A Repair

SEWAGE DISPOSAL SYSTEM

ADDRESS 13775 Triadelphia Road, Glenelg, Maryland 21737 PHONE 988-9270

LOCATION 7687 Kindler Rd. Laurel MD ZIP 21113

A 33607

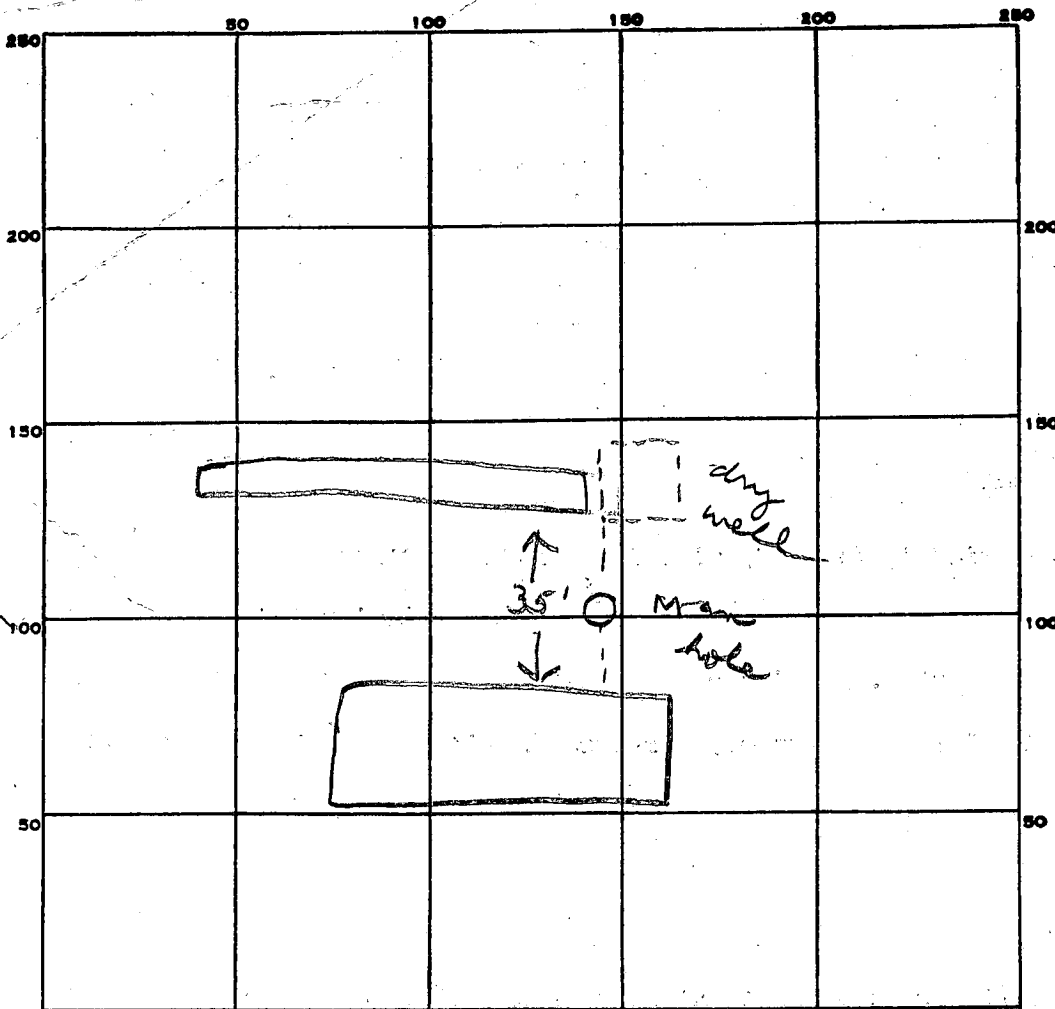
REMARKS 3/2/84 OK to add stone in trench. J

3/2/84 OK to cover all work. J

I, Hazel Templeton
measured depth to be
14 1/2 ft deep & dry -

AND APPROVED - 1 YR PREVIOUS. ~~1-3~~ FT. OF SOIL HAD WASHED OUT OF TRENCH. INSPECTION REVEALED SLIGHTLY ERODED DRAINAGE SWALE FEEDING INTO TRENCH. ONE RAIN GUTTER DUMPING TO SWALE. INFORMED MRS TEMPLETON THAT CORRECT REMEDY WOULD REQUIRE DIVERSION OF RUNOFF AWAY FROM TRENCH AREA.
